1. Forest Hills Lookout Subdivision Morrison Addition  
KPB File 2026-031  
Johnson Surveying / Morrison  
Location: Paper Birch Lane, Quillback Drive & Moran Street  
Sterling Area

# Forest Hills Lookout Subdivision Morrison Addition Preliminary Plat

**ITEM #2 - PRELIMINARY PLAT  
FOREST HILLS LOOKOUT SUBDIVISION MORRISON ADDITION**

**STAFF REPORT**

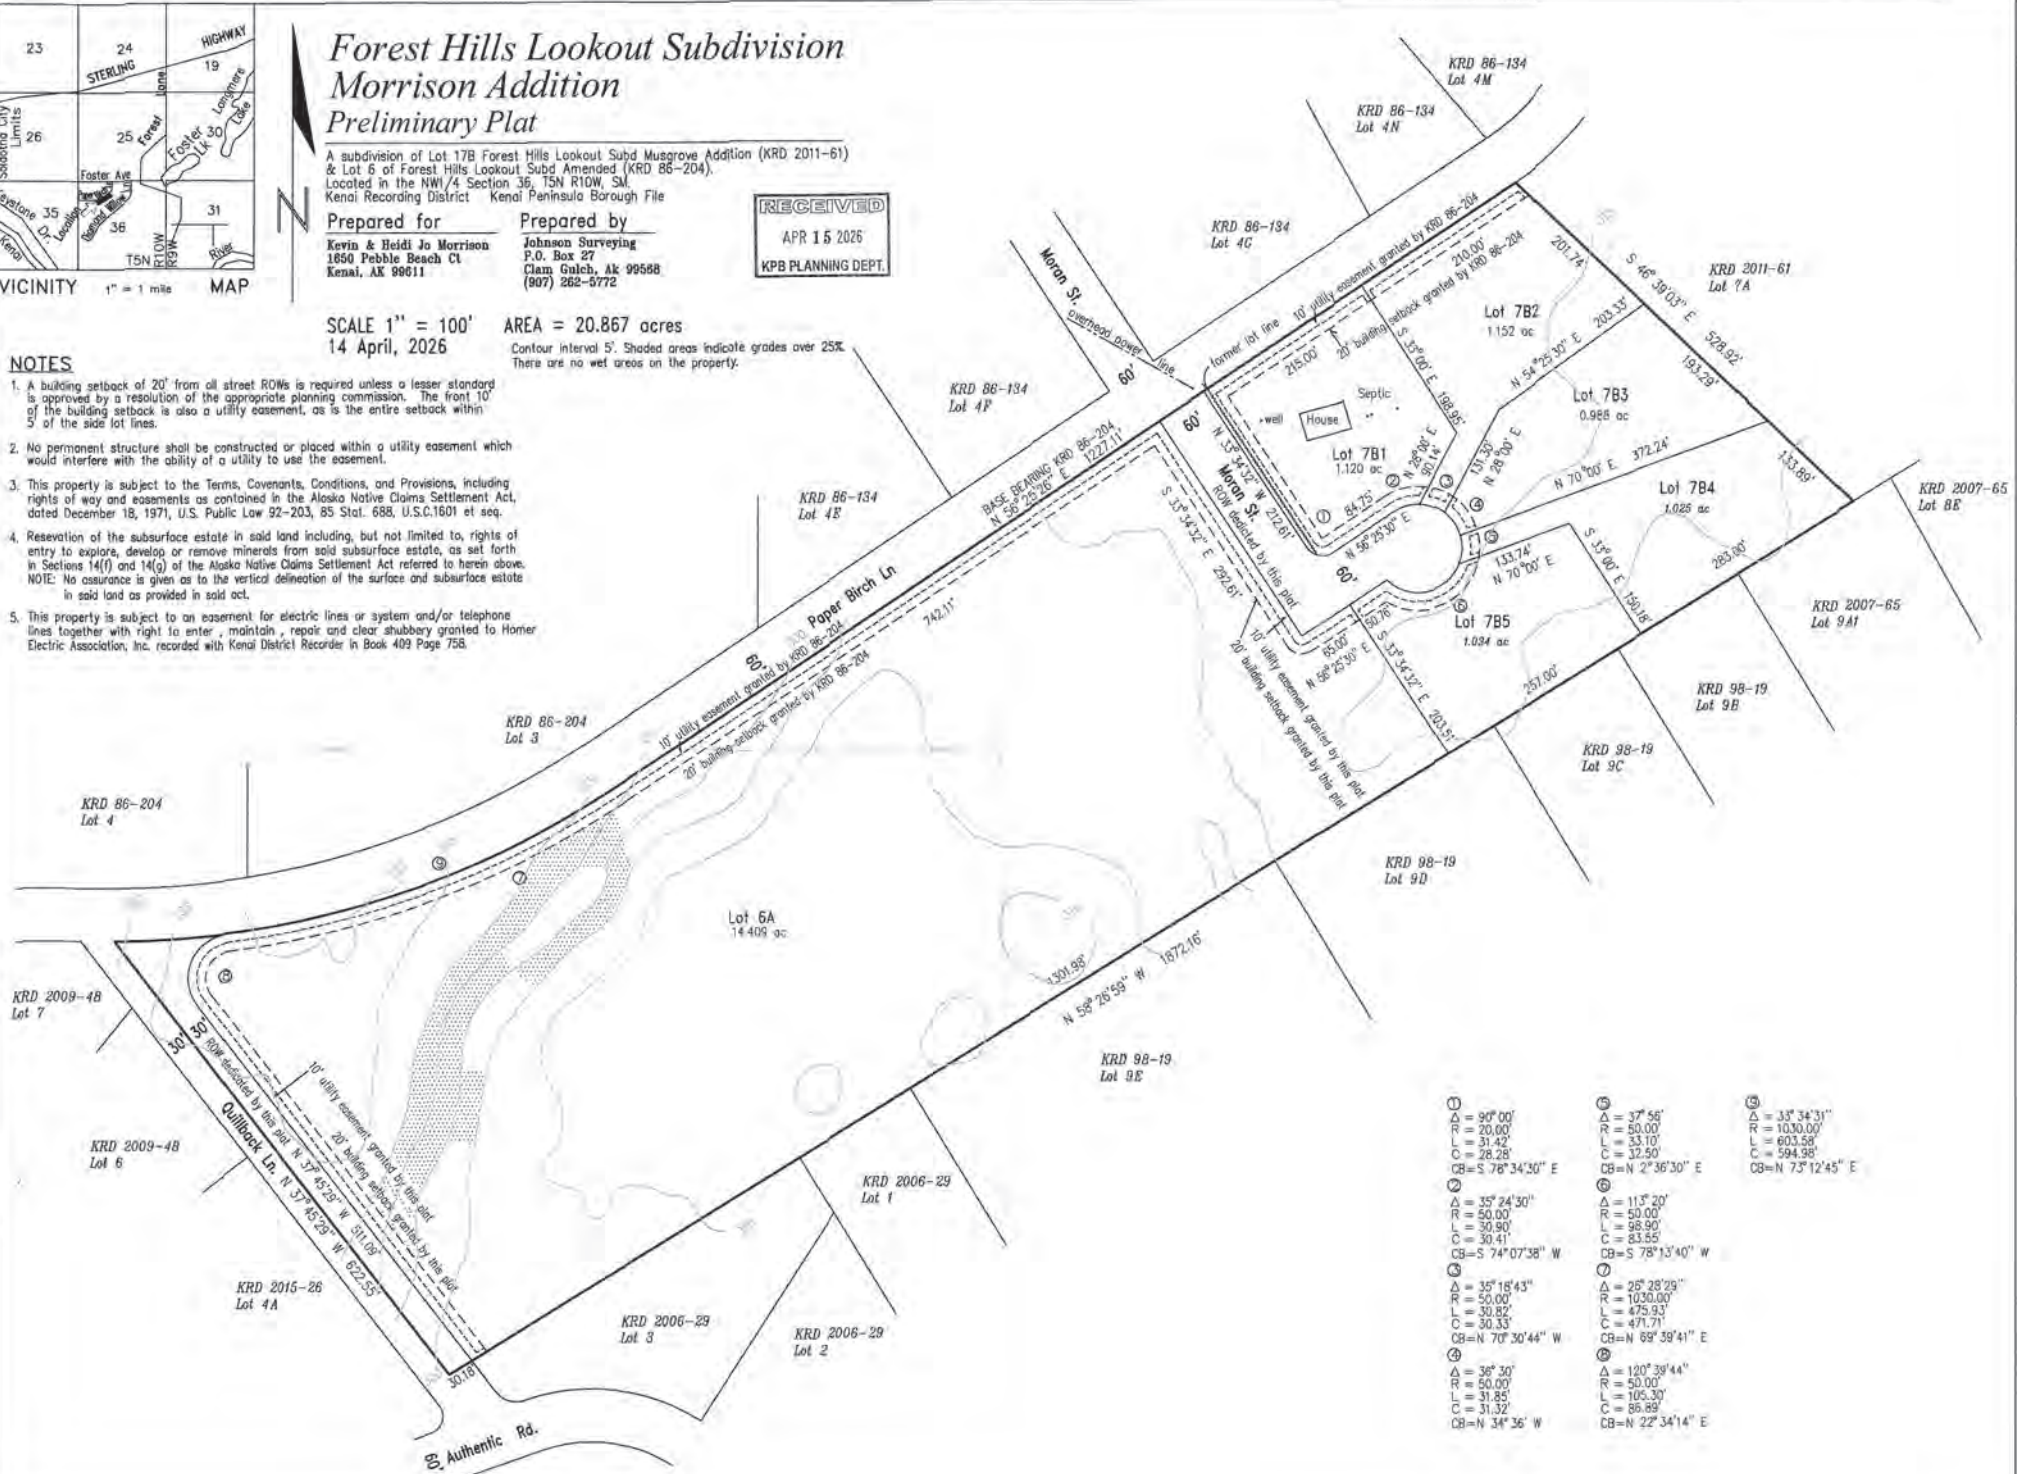
The proposed plat dedicates a 60-foot right-of-way terminating in a cul-de-sac, providing access to all the proposed lots of the plat. Per KPB 20.30.150.B. Offset intersections are not allowed, the location of Moran right-of-way as comes off Paper Birch Ln should be adjusted. Across from the proposed Moran St is the dedication of Moran St, as proposed they are offset 30' center of road to center of road. Additionally, the intersection with Paper Birch Lane must include round corners. KPB RSA oppose the proposed cul-de-sac design, as it does not provide an adequate turnaround and sufficient area exists to dedicate a full cul-de-sac. **Staff recommends** the applicant work with the KPB RSA to submit a revised cul-de-sac design to suite their standards, relocate the intersection to meet code, and incorporate rounded corners at the intersection. The applicant should also confirm the new street name with the KPB Addressing Officer and provide verification to the Platting Department, as well as confirm the driveway location for Proposed Lot 6A.

A revised patent (50-84-0415) reserved easements within the aliquot section. **Staff recommends** the applicant verify whether these easements do not affect the proposed plat. If they do, a plat note must be added addressing the easements; if not, written confirmation should be provided to the Platting Department.

KPB Roads Dept. comments	Out of Jurisdiction: No  Roads Director: Uhlin, Dil Comments: RSA objects to this plat. KPB 20.30.100. - Cul-de-sacs requires a a suitable turnaround with a minimum radius of 50 feet. There is ample room to do this at the end of Moran St. Having a 90 degree turn that leads immediately to a substandard hammer head will cause issues with future road maintenance and may affect large emergency service vehicles.
SOA DOT&PF comments	No comments

KPB reviewers have determined that the proposed plat is located within a non-regulatory X-Unshaded flood zone. No depiction is required. **Staff recommends** adding the standard Flood Hazard note referencing the flood zone and FIRM map panel 02122C-0930F.

Proposed Lots 7B2 and 7B4 are designed as flag lot. The access portions exceed 20 feet in width and do not exceed 150 feet in length. **Staff recommends** adding the standard flag lot note to the final plat.

Proposed lots 7B1 through 7B5 are each less than 200,000 square feet; therefore, a soils report is required and an engineer must sign the final plat. Proposed Lot 6A exceeds 200,000 square feet and does not require a soils report. **Staff recommends** adding the applicable waste water disposal notes to the final plat in accordance with KPB 20.40

HEA has reviewed the plat and requests plat note 5 be removed, as the easement is located solely on Lot 7A, Plat KN 2011-61 and does not affect this subdivision.

Add a plat note about the CCR's listed at the CTP at item 3

- o To conserve both parent plat names, please revise the subdivision name. Staff suggests "Forest Hills Lookout Musgrove Addition Morrison Replat."
- o Modify Lot 17B to Lot 7 B (KN 2011-61).

- Add KPB File # 2026-031
  - Modify Ownership information to: Kevin C. Morrison and Heidi Jo AKA Heidi J. Morrison
- C. The location, width, and name of existing or platted streets and public ways, railroad rights-of-way, and other important features such as section lines or political subdivisions or municipal corporation boundaries abutting the subdivision;

**Staff recommendation:**
- Revise the name of “Quillback Drive”
- F. The location, width and name of existing and platted streets and public ways, railroad rights-of-way, easements, and travel ways existing and proposed, within the subdivision;

**Staff recommendation:**
- Patent 50-84-0415 reserved easements within the affected aliquot section.
- G. The status of adjacent lands within 100 feet of the proposed subdivision boundary or the land status across from any dedicated rights-of-way that adjoin the propose subdivision boundary, including names of subdivisions, lot lines, block numbers, lot numbers, rights-of-way; or an indication that the adjacent land is not subdivided;

**Staff recommendation:**
- Modify Lot 4 to Lot 2 (KN 86-204)

Offset intersection is not allowed. Align Moran St. intersections. Provide rounded corners at the intersection of Moran St. and Paper Birch Ln.

Confirm with Addressing Officer of cul-de-sac name.

**Staff recommendation:** *place the standard note on the plat for the flag lot(s): No structures or wastewater disposal are permitted within the panhandle portion of the flag lot(s).*
